CHRYSLER A604 (41TE) UPDATE HANDBOOK

*Updated
May, 2003*

"UPDATE HANDBOOK"

Figure 1

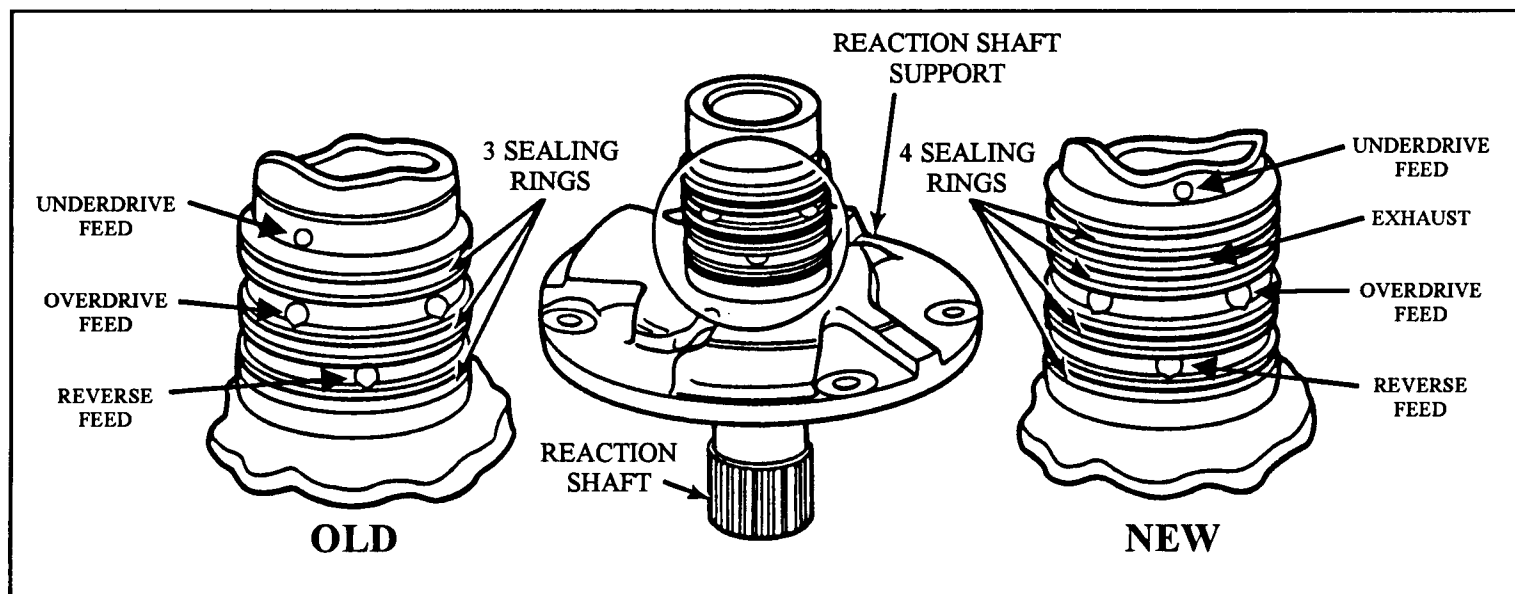
CHANGE: Beginning in April, 1989 a new Reaction Shaft Support (Stator) was introduced, with the addition of another ring groove and sealing ring. The old support has 3 sealing rings, and the new support has 4 sealing rings (See Figure 1).

- (1) **REACTION SHAFT SUPPORT** - The new support is longer, and has 4 sealing rings, where the old support only has three (See Figure 1).
- (2) **INPUT SHAFT/CLUTCH HUB** - The new Input Clutch Hub bore is machined deeper to accommodate the additional length of the reaction shaft, created by the added sealing ring (See Figure 2). The "O" Ring grooves are also cut shallower than the old input clutch hub, which increases the groove diameter, and provides improved compression or "Crush", between the "O" rings and the input clutch retainer. (See Figure 3).

Figure 3

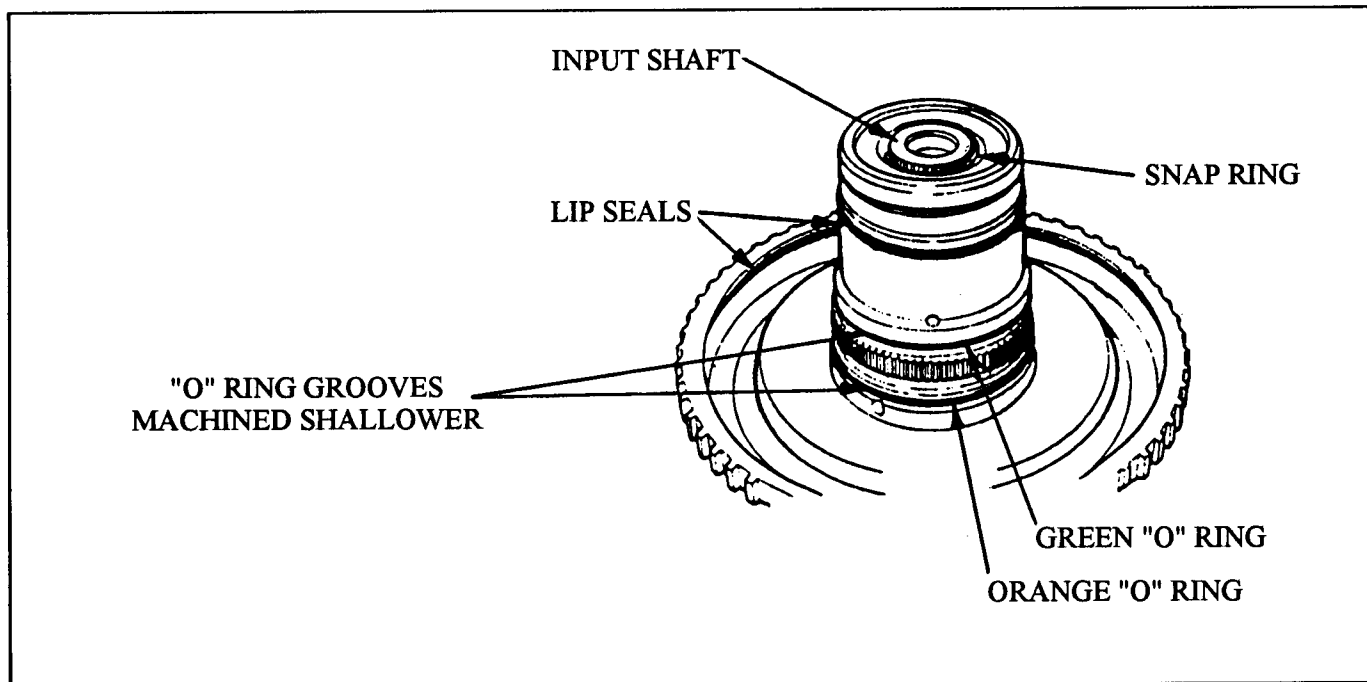
- (3) **INPUT SHAFT/CLUTCH HUB "O" RINGS** - The new "O" Rings are "Teflon Coated" for greater tear resistance during the assembly process. The coatings also identify the locations for the "O" Rings. The orange ring goes to the front, and the green one goes to the rear (See Figure 3). The early "O" rings were black.

Figure 4

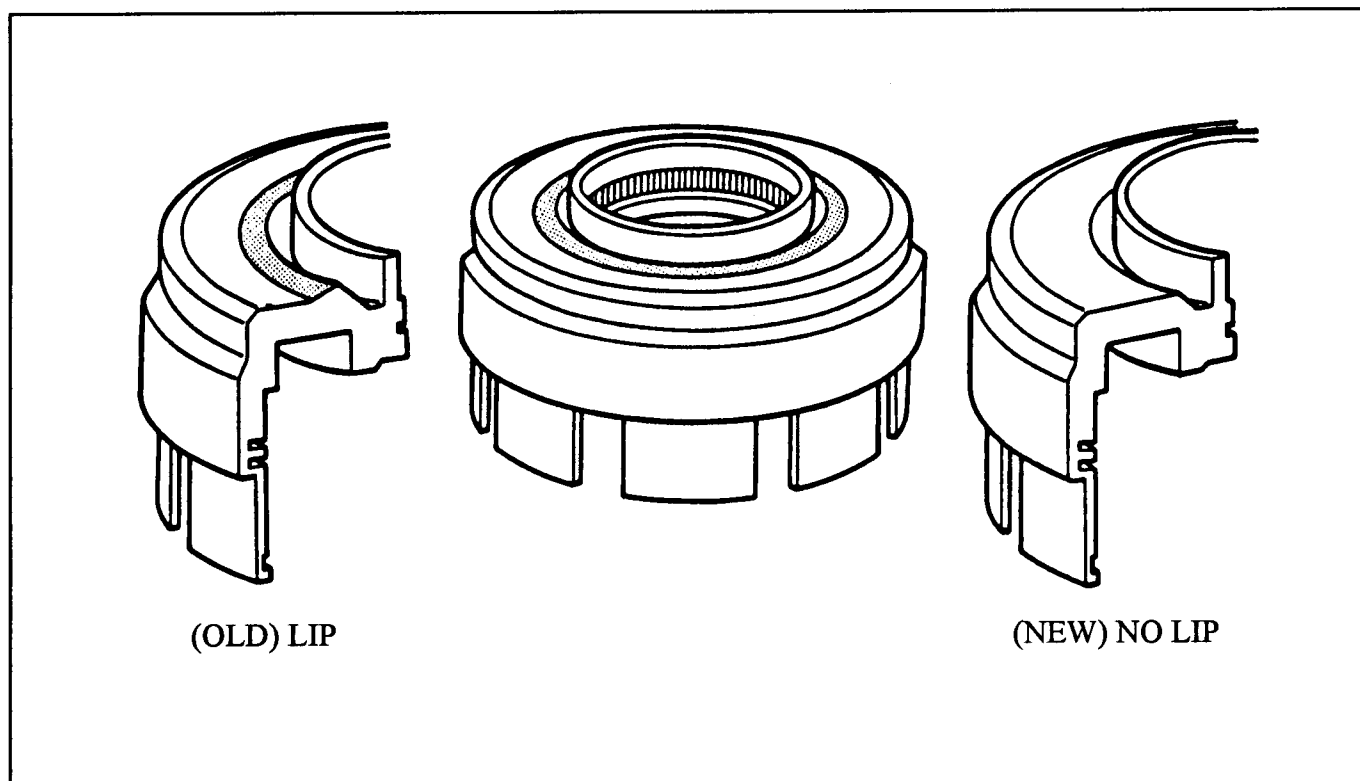
- (4) **INPUT CLUTCH RETAINER** - The Input Clutch Retainer was modified, by machining off the "Lip" (See Figure 4), to allow more travel of the overdrive/reverse piston. The old Input Clutch Retainer can be machined at the local machine shop if necessary.

Figure 5

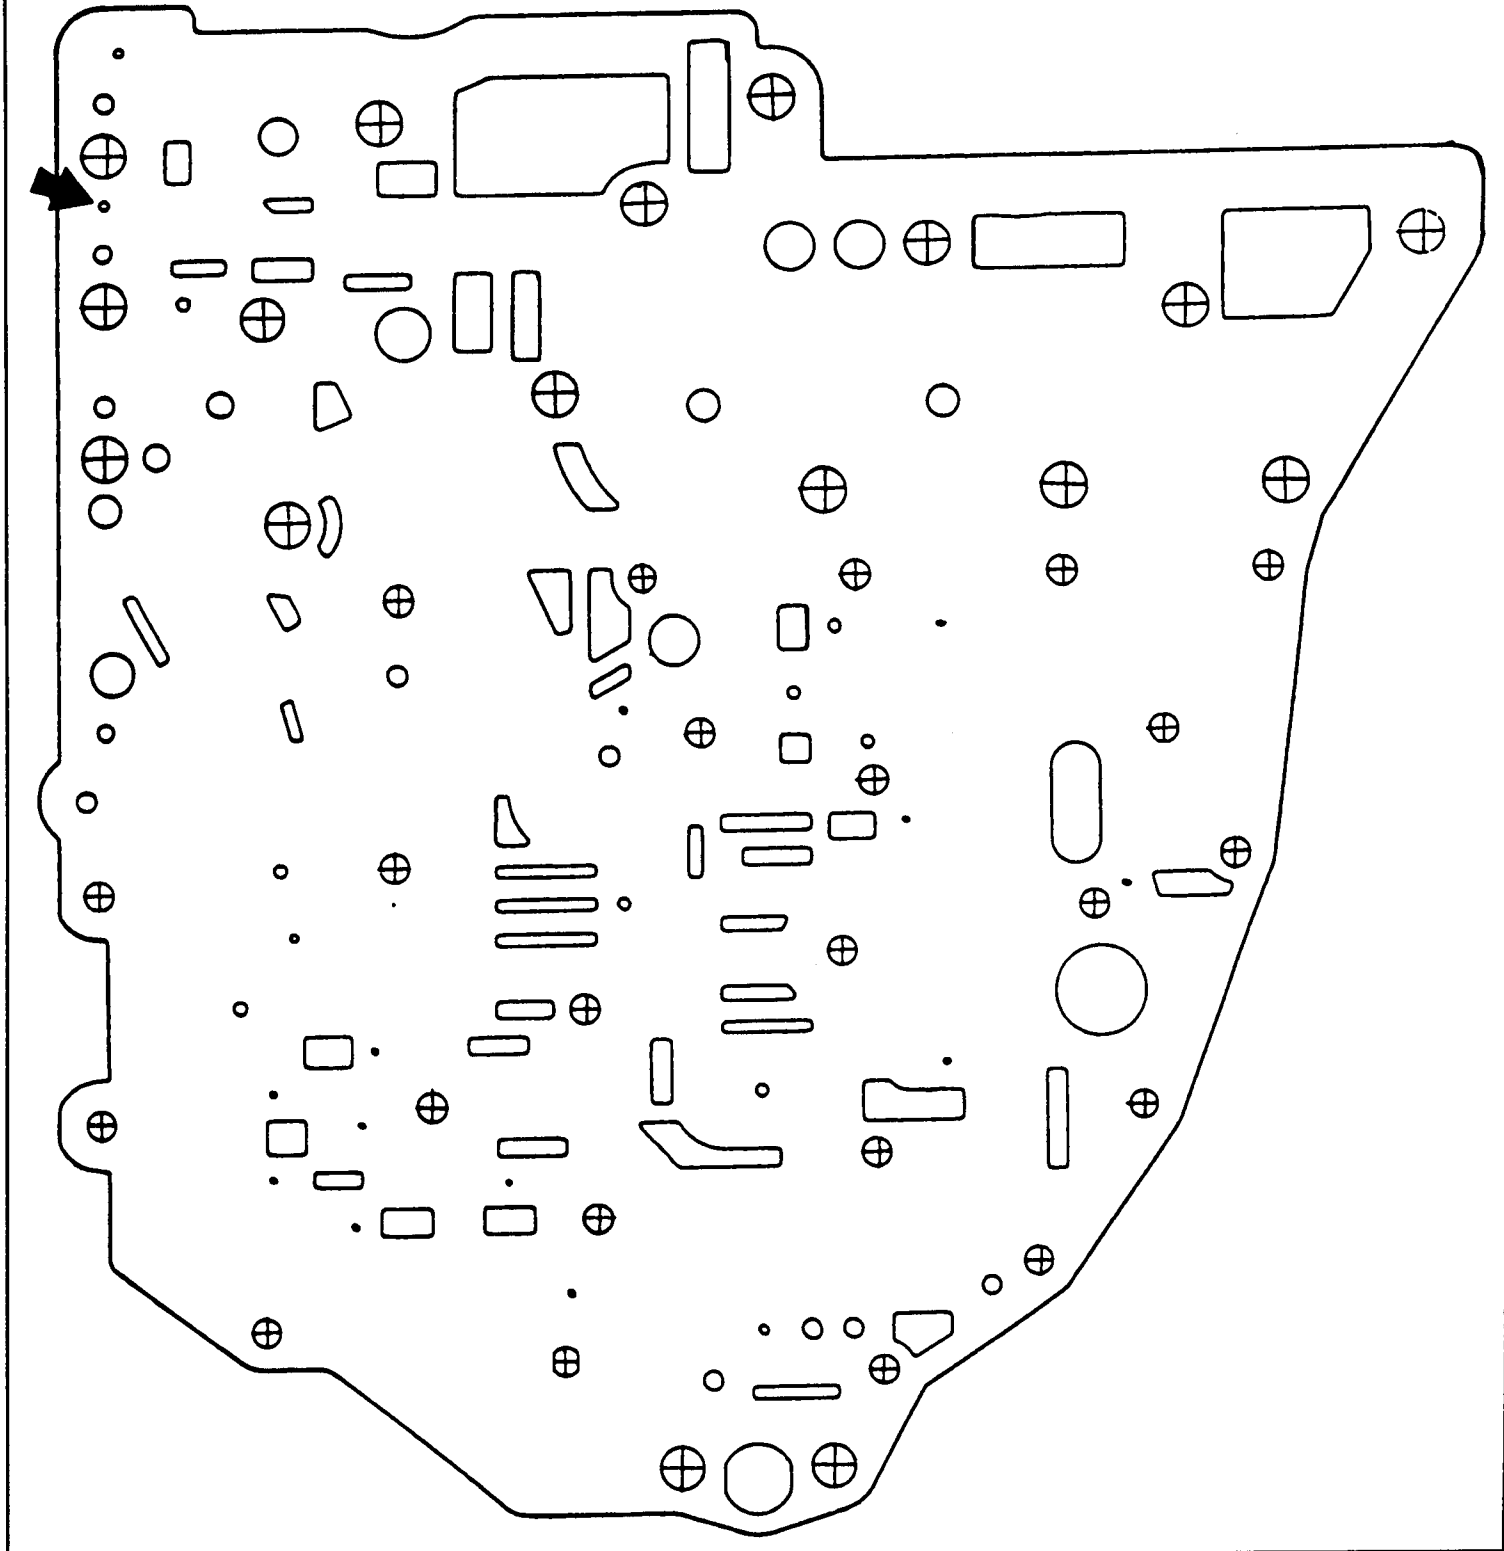
- (5) **SPACER PLATE** - The new Spacer Plate has a larger (.105") overdrive clutch feed orifice to provide increased oil flow to the overdrive clutch circuit (See Figure 5).

THE HOLE INDICATED BY THE ARROW BELOW HAS BEEN ENLARGED TO .105" FOR INCREASED OIL FLOW TO THE OVERDRIVE CLUTCH CIRCUIT.

Figure 6

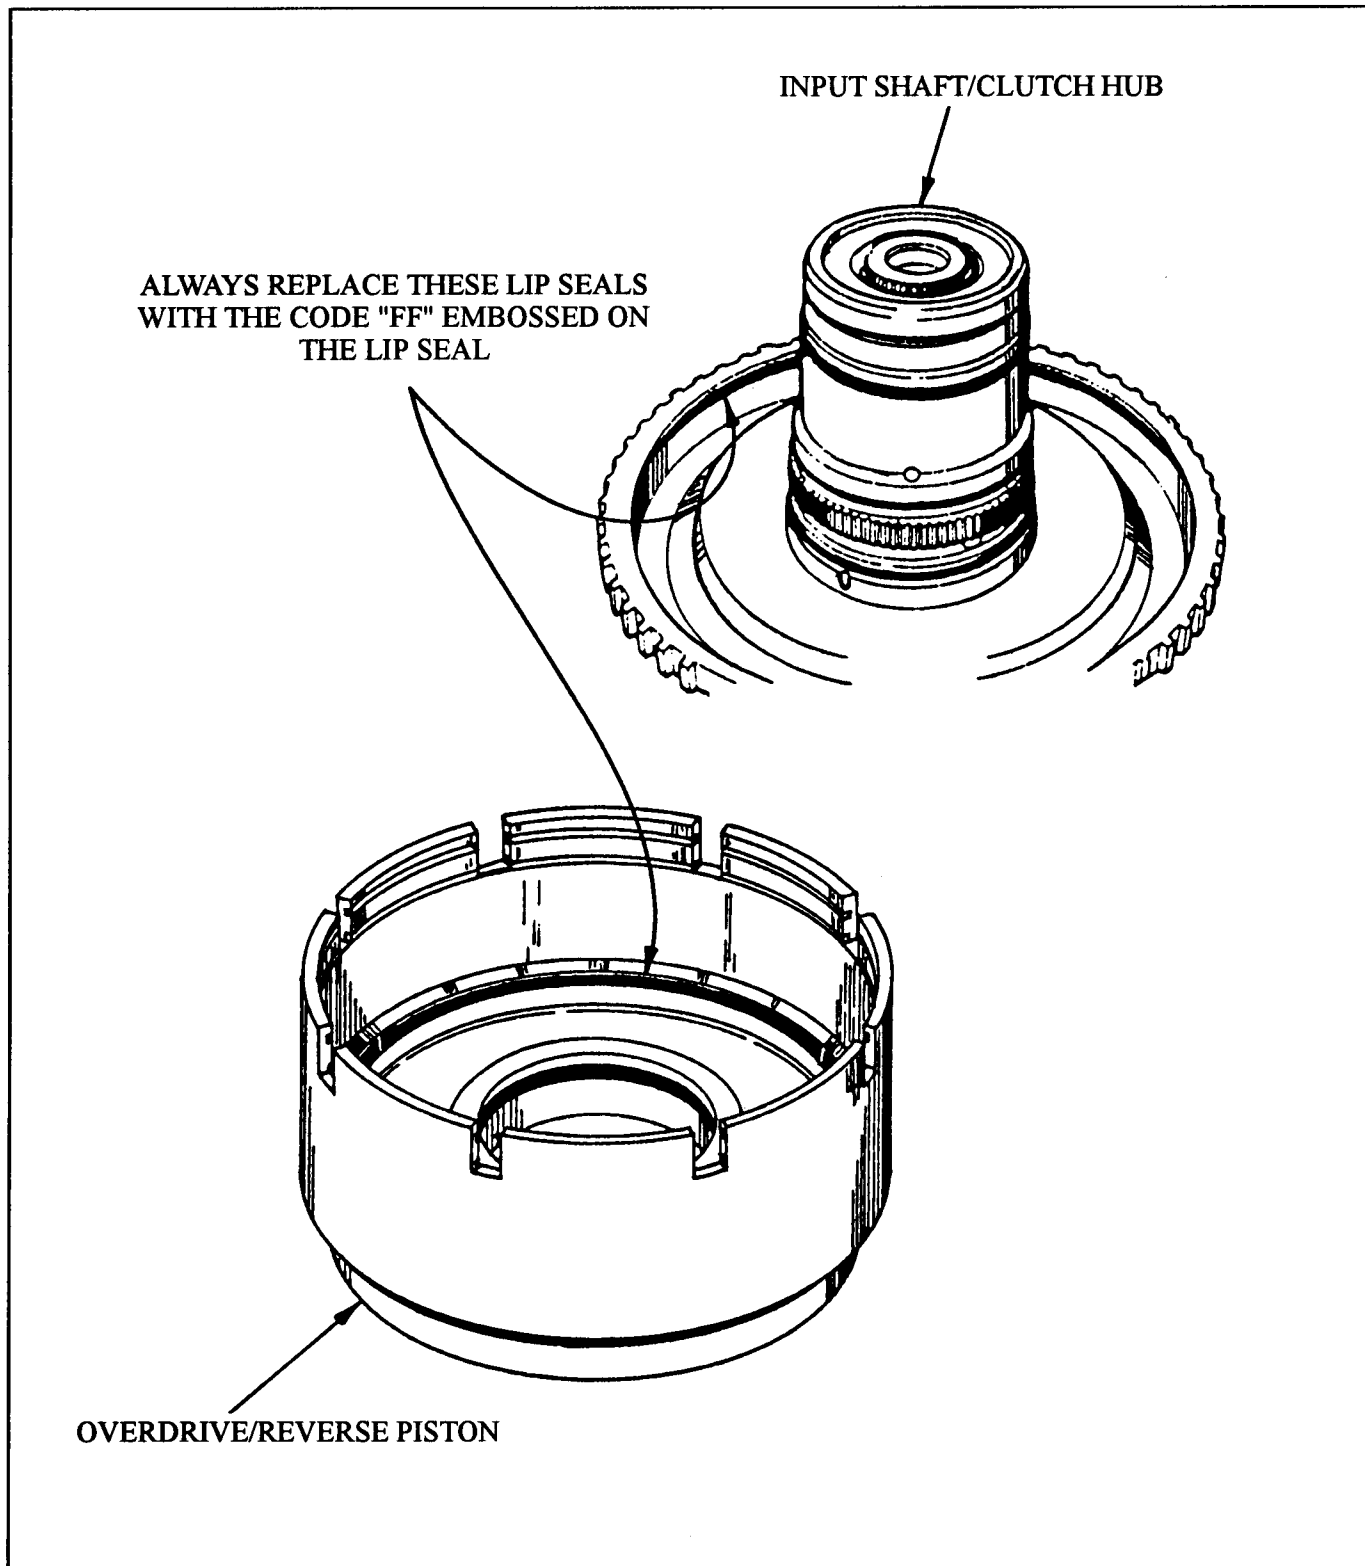
CHANGE: The lip seals in the Overdrive/Reverse Clutch Piston and the Input Shaft/Clutch Hub are now replaced with lip seals made of different material (See Figure 6).

- (1) OD/REVERSE PISTON LIP SEAL - No dimensional changes, but the material changes, and the new lip seals can be identified by the code "FF" embossed into the seal. The old lip seal is embossed with the code "IPC", and should not be used (See Figure 6).
- (2) INPUT CLUTCH HUB OUTER LIP SEAL - No dimensional changes, but the material changes, and the new lip seals can be identified by the code "FF" embossed into the seal. The old lip seal is embossed with the code "IPC", and should not be used (See Figure 6).

THE NEW LIP SEALS EMBOSSED WITH THE CODE "FF" WILL RETROFIT BACK TO ALL PREVIOUS MODELS, AND SHOULD BE USED DURING OVERHAUL.

Figure 14

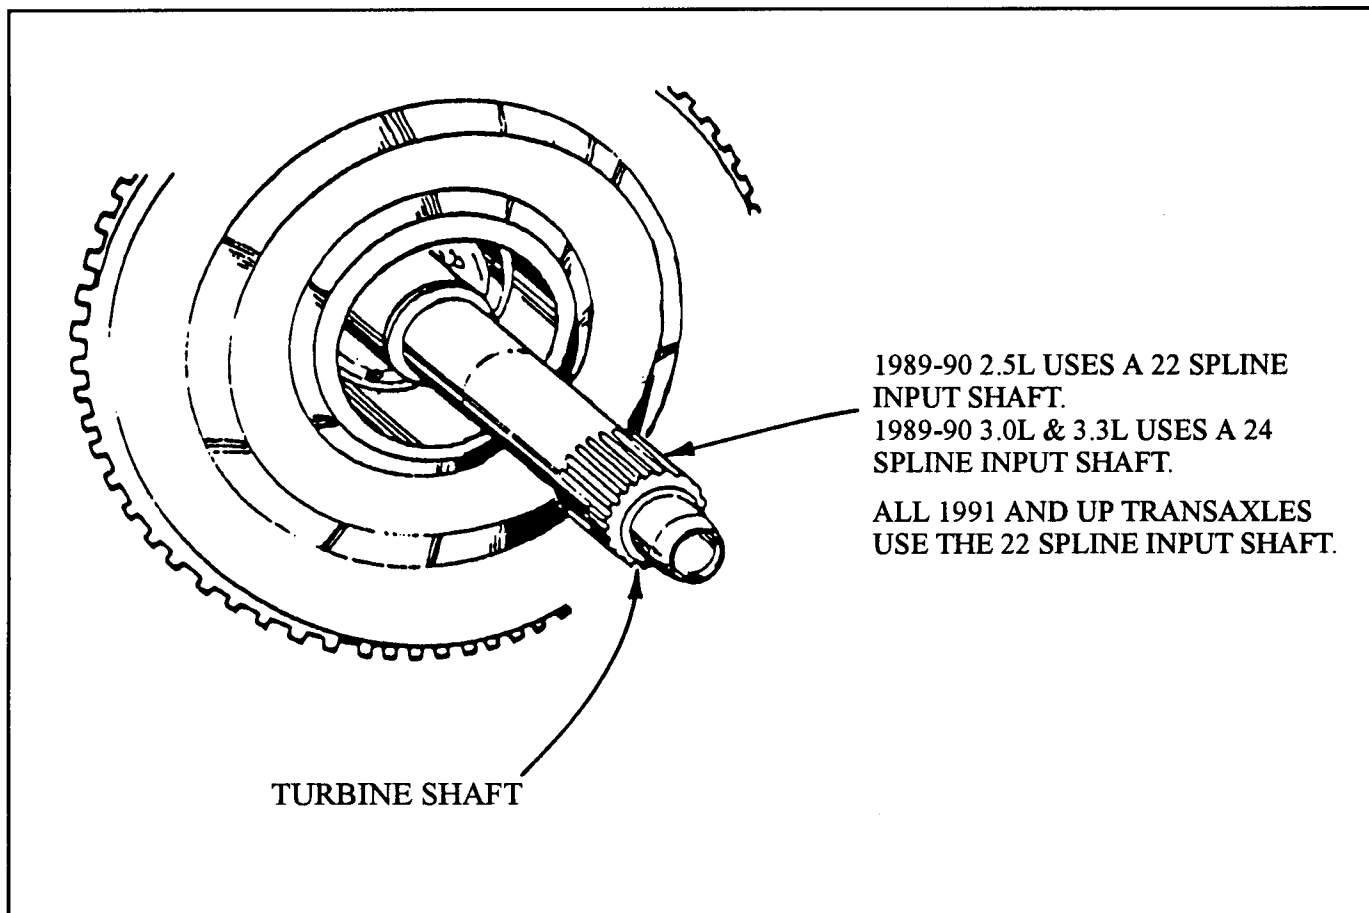
- (2) **TURBINE SHAFT SPLINES** - 1989-1990 2.5 Litre engine uses a turbine shaft with 22 splines for the torque converter, and the 1989-1990 3.0 and 3.3 Litre engines will use the a 24 spline turbine shaft (See Figure 14).

NOTE: All 1991 and up A604 transaxles will use a 22 spline input shaft to fit a new torque converter with a torsional vibration damper (See Figure 14).
